**CULTURAL RESOURCES OFFICE
 PRESERVATION BOARD
 REGULAR MEETING – ZOOM MTG.
 MONDAY JUNE 29, 2020 — 4:00 P.M.
www.stlouis-mo.gov/cultural-resources**

DATE: June 29, 2020
ADDRESS: 1910 Rutger Street
ITEM: Preliminary Review: Retaining Wall at Front Facade
JURISDICTION: Lafayette Square Local Historic District — Ward 6
STAFF: Andrea Gagen, Cultural Resources Office

DATE: June 29, 2020
ADDRESS: 1116 Missouri Avenue
ITEM: Preliminary Review: Construction of a 5-story apartment building.
JURISDICTION: Lafayette Square Local Historic District — Ward 6
STAFF: Jan Cameron, Cultural Resources Office

DATE: June 29, 2020
ADDRESS: #9 Benton Place
ITEM: Appeal of the Director's Denial to Construct Enclosed Side Porch Addition
JURISDICTION: Lafayette Square Local Historic District — Ward 7
STAFF: Andrea Gagen, Preservation Planner, Cultural Resources Office

PLAN VIEW OF PROPOSED RETAINING WALL

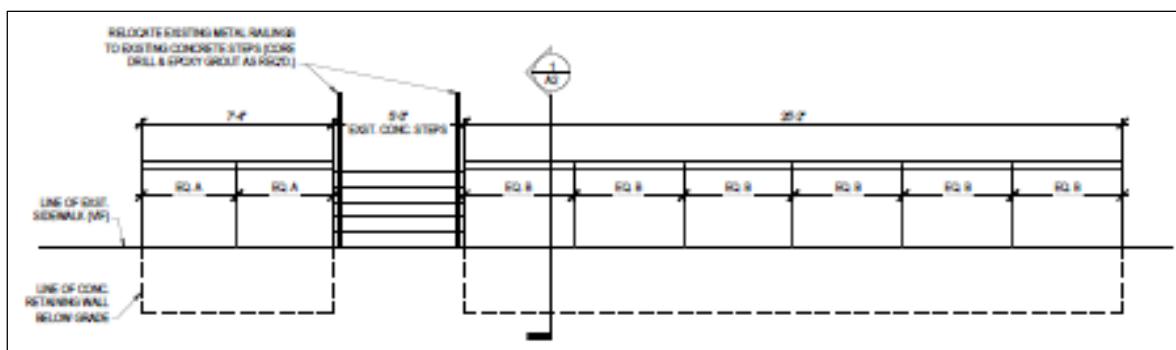
Does not comply. The historic slope of the yard is being altered.

Partially complies. While the material of the wall simulates cut stone, the proposed wall is considerably taller than the submitted HME, which is curbing, not a retaining wall. The submitted curbing at 18th & LaSalle is not an appropriate HME.

- The proposed site for the retaining wall, 1910 Rutger Street, is located in the Lafayette Square Local Historic District.
- The proposed retaining wall will alter the historic slope of the yard.
- The proposed retaining wall is not based on an appropriate HME, as what was submitted is not a retaining wall.
- Although the material of the wall may meet the historic district standards, the height and design of the wall do not.

Based on the Preliminary findings, the Cultural Resources Office recommends that the Preservation Board deny preliminary approval to the design as currently presented as it does not comply with the Lafayette Square Historic District Standards.

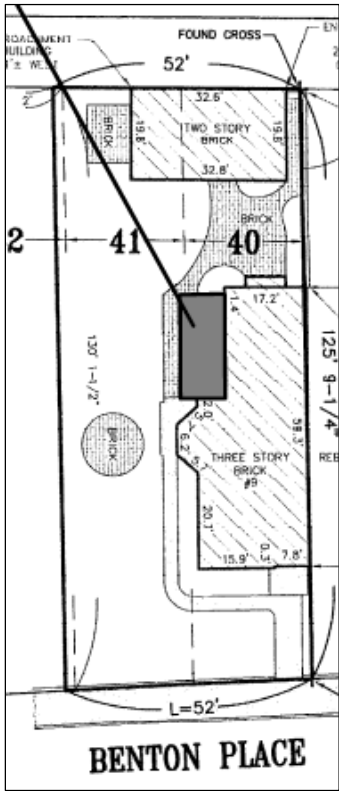
- 9 Benton Place is located in the Lafayette Square Local Historic District.
- Although the proposed addition does not comply with the Exterior Materials and Color section of the Lafayette Square Standards, there was an existing porch at this location and the Cultural Resources Office believes that a frame addition resembling an enclosed porch is appropriate at this location.
- The Standards require that the Exterior Materials reflect those of the HME, which in this case is an oriole window on the rear elevation of existing house. Although the addition is not brick as required by the Standards, its design is based on the detailing of that window.
- The details of the cornice are similar to the existing oriole window, but the base trim should be revised to match the window detailing more closely. The owner has agreed to this change.

Based on these preliminary findings, the Cultural Resources Office recommends that the Preservation Board overturn the Director's denial of the application as substantially meets the Lafayette Square Local Historic District Standards, with the stipulation that the details be approved by the Cultural Resources Office staff.

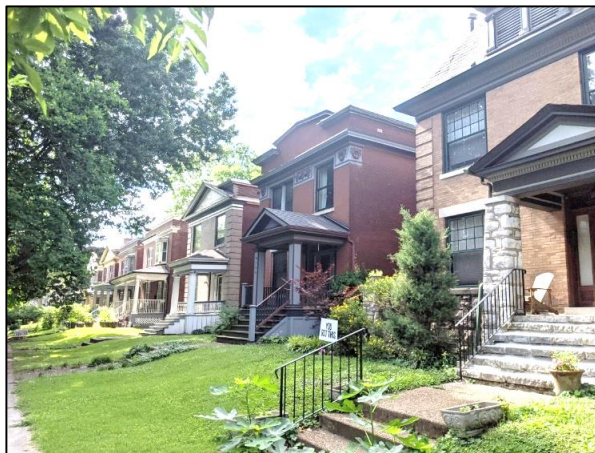
Does not comply. The historic roofing material is extant and is slate. GAF Slateline is not an approved replica for slate: a synthetic slate would fulfill this requirement.

Does not comply. GAF Slateline does not replicate the historic material.

Based on these preliminary findings, the Cultural Resources Office recommends that the Preservation Board uphold the Director's Denial to replace the slate roofing material with GAF Slateline as it is not an approved replica material per the Historic District Standards.
